**RE: RESPONSE TO GOLD COAST CITY COUNCIL INFORMATION
REQUEST - DEVELOPMENT PERMIT FOR MAKING A MATERIAL
CHANGE OF USE FOR EXTENSIONS TO EXISTING INDUSTRY AND
WAREHOUSE.**

PROPERTY: 82 CHRISTENSEN ROAD, STAPLYTON (LOT 240 ON W31320)

APPLICATION NO.: MCU 201200283

Attachment A Waste Servicing, Loading Bays and Set Down Areas and Stage Boundaries

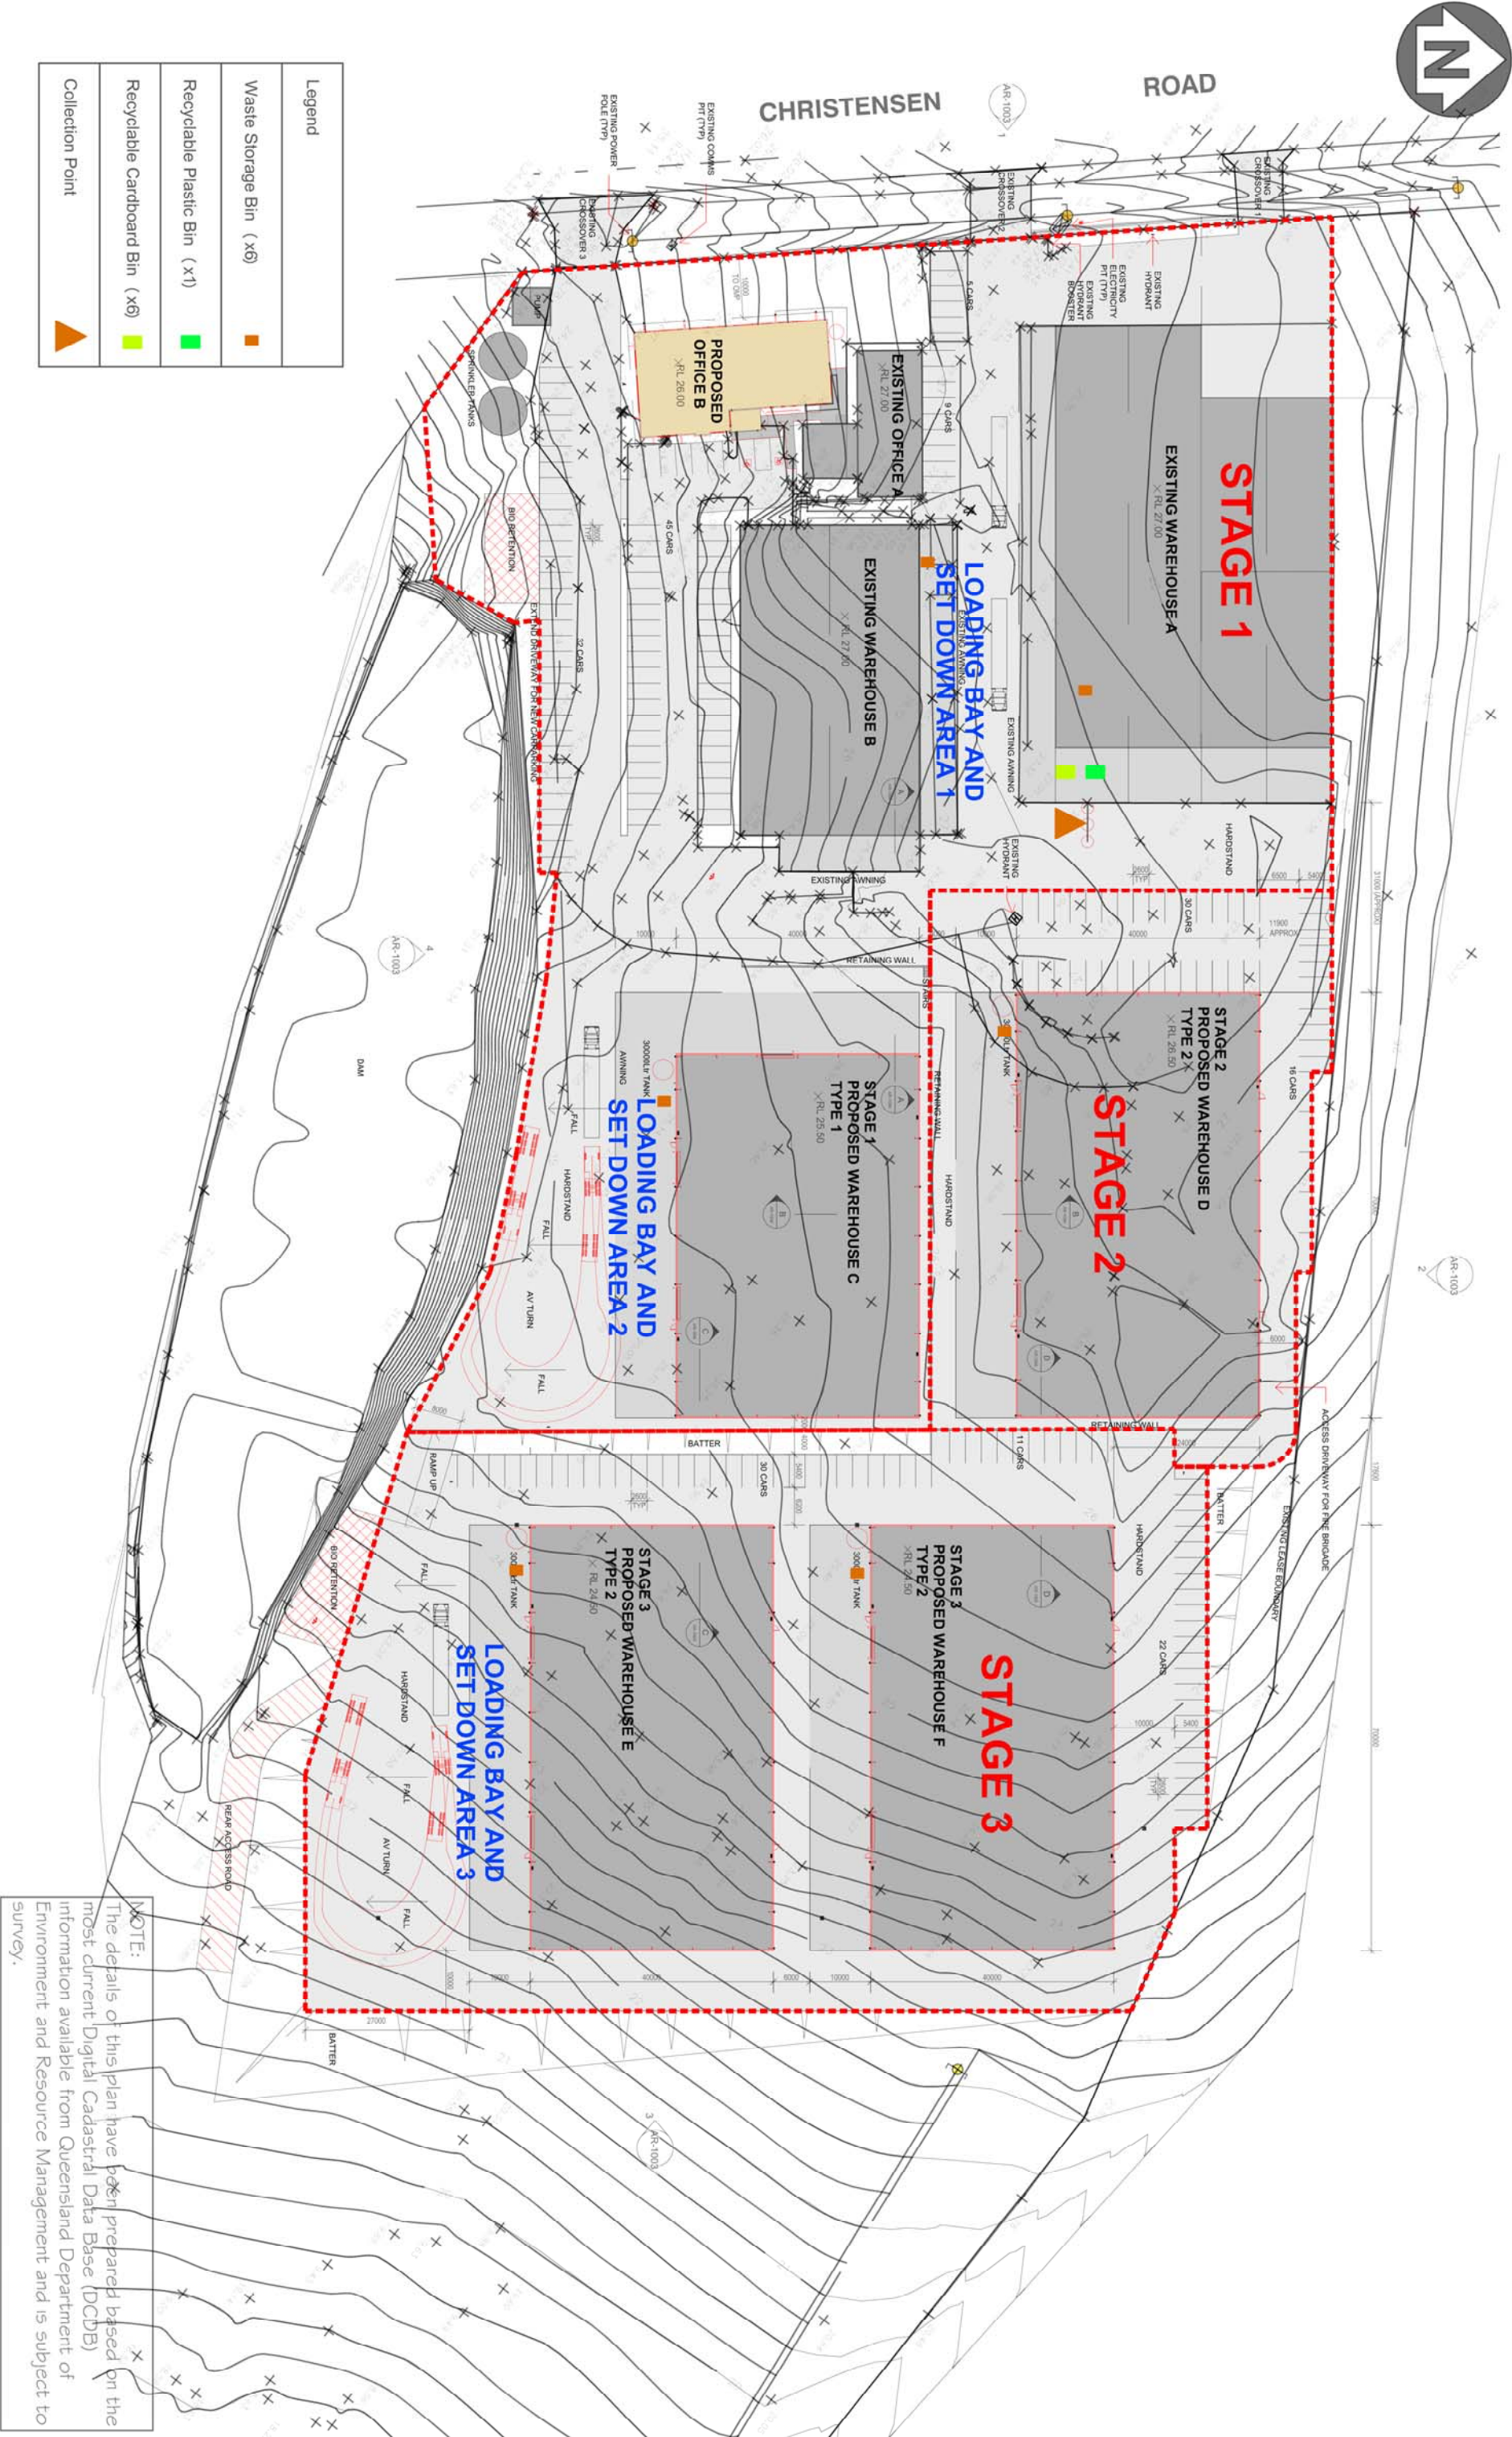
The applicant is requested to provide further information with regard to the proposed waste storage and servicing facilities and or waste storage and servicing arrangements for the proposed development. The application is requested to provide further information including details of the solid waste management facilities storage and servicing arrangements for the development. Submitted information must include:

- *Expected weekly waste generation for the development and type / size of waste containers for general, recyclable and development specific waste streams; and*
- *Plans detailing the location, size and design of all storage point/s, servicing point/s, internal servicing roadways, service vehicle, clearance and manoeuvrability, and waste removal systems.*

The applicant is requested to amend plans to clearly designate loading bays and set down areas on plans to demonstrate full compliance with PC13 of the Car Parking, Access and Transport Integration Constraints Code. It is requested that appropriate locations of signage and line marking be delineated on plans.

The applicant is requested to amend plans to clearly delineate the boundaries of each stage of development and demonstrate that parking is provided in accordance with PC16AS16.1 of Car Parking, Access and Transport Integration Constraints Code, at each stage. Further consideration should be taken on potential impact on parking, access and service vehicle manoeuvring during stages of construction.

In accordance with this request from Council, please find attached drawing **1292 CP 02A** in **Appendix A**, prepared in support of this I.R. response, illustrating the location of proposed waste storage points and collection points. Given that the application relates to an existing operation the proposals for waste management have been derived from the existing waste servicing arrangements successfully utilised on site.

There are currently six (6) three (3) metre cubed bins located on site (illustrated on plan), these bins are taken to a collection point twice a week for collection and approximately 30 metres cubed of solid waste is generated each week.

In order to manage and service waste as part of the new development new bins will be provided for compaction and recycling. Six (6) three (3) metre cubed bins will be retained for general waste, to be emptied once a week. One (1) six (6) metre cubed bin will be introduced for recyclable compactible waste, to be emptied once a week. One (1) six (6) metre cubed will be introduced for recyclable cardboard, to be emptied once a week. The location of each storage point is illustrated on the drawing **1292 CP 02A**.

Each stream of waste will be collected on specified days at centralised collection points, as illustrated on the attached plan. The main waste generated by the operation will be plastic and cardboard. By compacting and recycling the waste produced the increase in waste production will be relatively minor, approximately six (6) metres cubed per week, resulting in a total weekly waste production of approximately 36 metres cubed per week.

In accordance with this request from Council and updated drawing of the proposed development with designated loading bays and set down areas identified has been provided. As explained within the TIA submitted as part of the application, proposed warehouses D and F will be serviced by the set down areas located south of the warehouses C and E respectively. The applicant acknowledges the proposed layout and servicing arrangement is not standard, however it is considered that due to the unique shape of the subject site, the established nature of the existing business operating on site and the relationship between the proposed warehousing units, the proposed servicing arrangement is considered appropriate.

In accordance with this request from Council, clearly annotated stage boundaries have been provided on an updated plan. This plan clearly delineates the proposed stage boundaries relating to the application. The identified boundaries of each stage have been designed to ensure that adequate parking has been provided in each stage of the development in order to ensure each stage of development can operate efficiently.

Landscape Intent / Pedestrian Routes

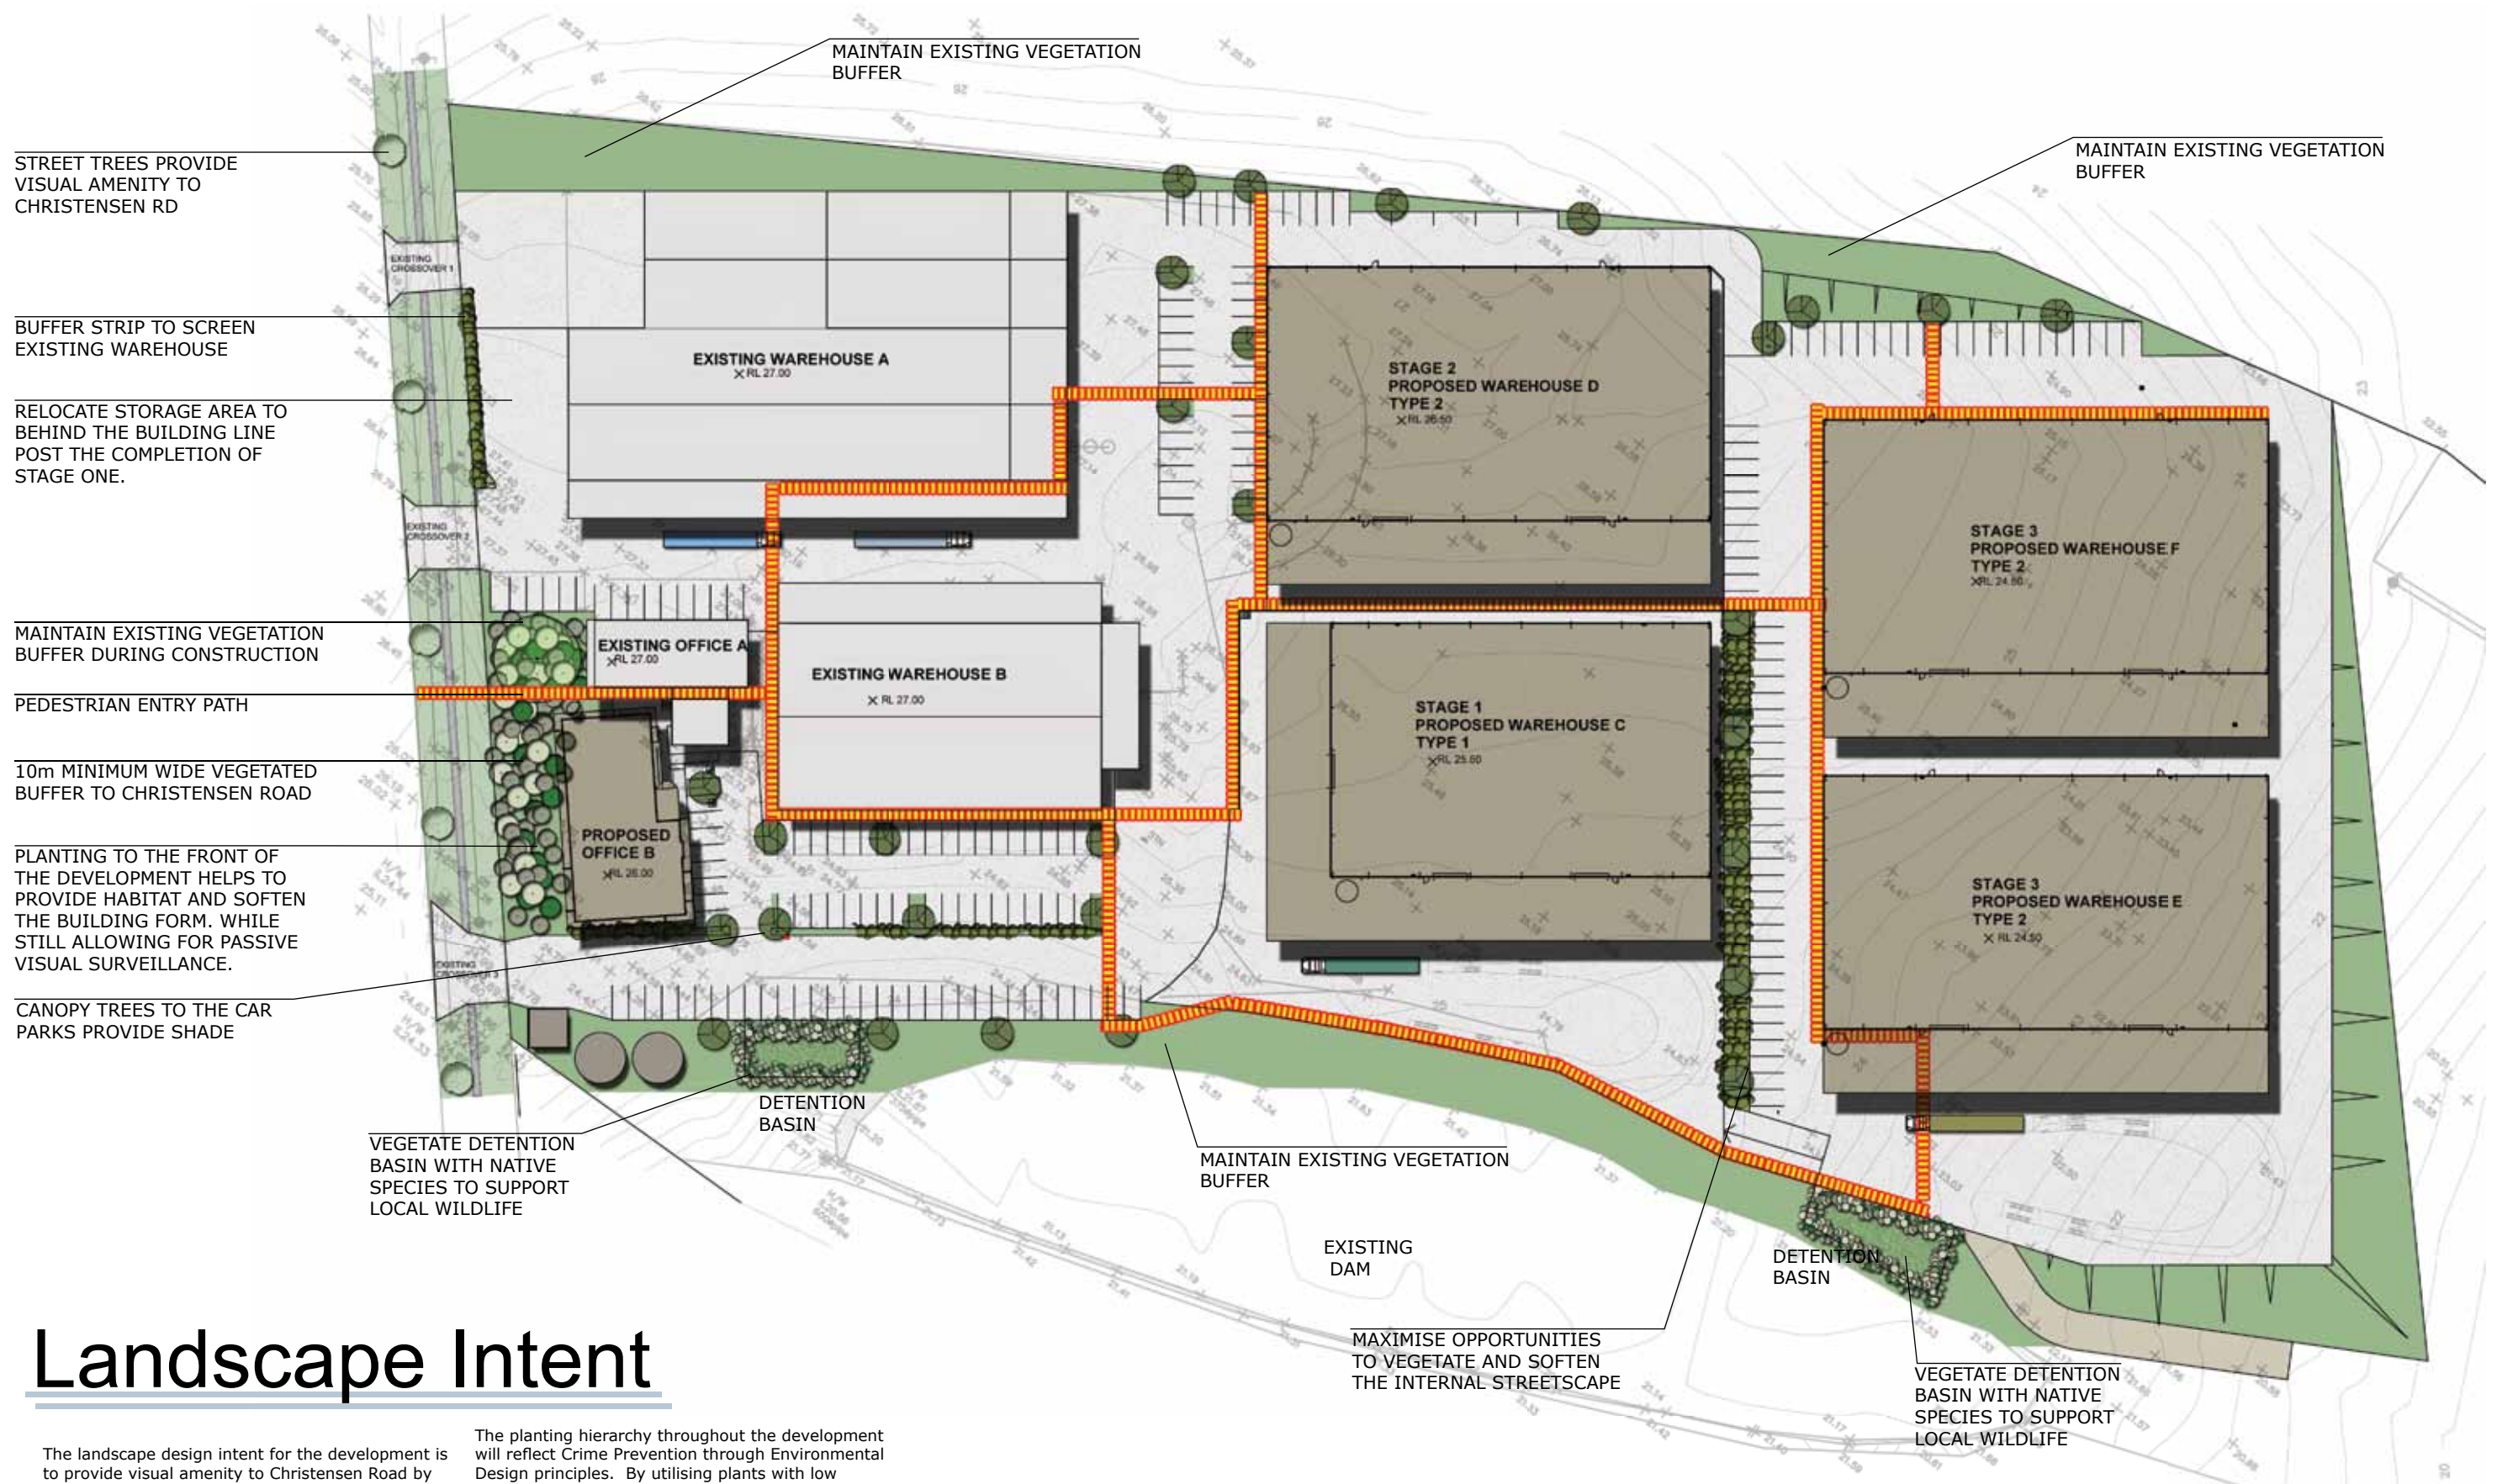
Council officers are aware that in late 2010 a significant portion of garden located at the frontage of Existing Warehouse A was converted to hardstand and is currently being used for storage purposes (the location of this garden area is shown below in Figure 1). Council officers maintain that this garden area was approved under Landscaping Operational Works Application OPW2101335, and is required to be retained in the development. Accordingly, the application is requested to amend all proposal plans (including the statement of landscape intent) to show the full reinstatement of this garden. This portion of the site is important to visual amenity viewed from Christensen Road, and is not suitable for storage purposes.

The applicant is requested to amend site plans to clearly show provisions of pedestrian footpaths and crossings to demonstrate compliance with PC8, PC19 and PC20 of the Car Parking, Access and Transport Integration Constraints Code.

In accordance with this request from Council, the applicant acknowledges that the subject area is currently being used as a hardstand storage area, and has committed to improving the treatment and aesthetics of the area. Specifically it is intended to relocate this storage to the rear of the site (behind building line) in accordance with this proposed development. It is currently anticipated that there will be sufficient ability and new hardstand area for this successful relocation to occur post the completion of Stage One.

Further, following relocation of this storage to the rear, intensive remedial landscaping works are proposed. This should soften the transition between road reserve and built form. As highlighted on the revised landscape drawings that have been prepared in support of this I.R. response this

strategy would include establishing more intensive landscaping within the existing landscaped strip in effect framing the views of the subject lot.

In accordance with this request from Council, please find attached updated landscaping drawing **1292 L LI 01D** that illustrates the proposed pedestrian paths that will service each element of the proposed development. The proposed pedestrian routes have been designed to ensure that each element of the proposed development including structures, car parking and amenity areas are readily and easily accessible by foot. Pedestrian safety has also been a key consideration in designing the identified routes, in this regard every effort has been made to avoid vehicular intersections.
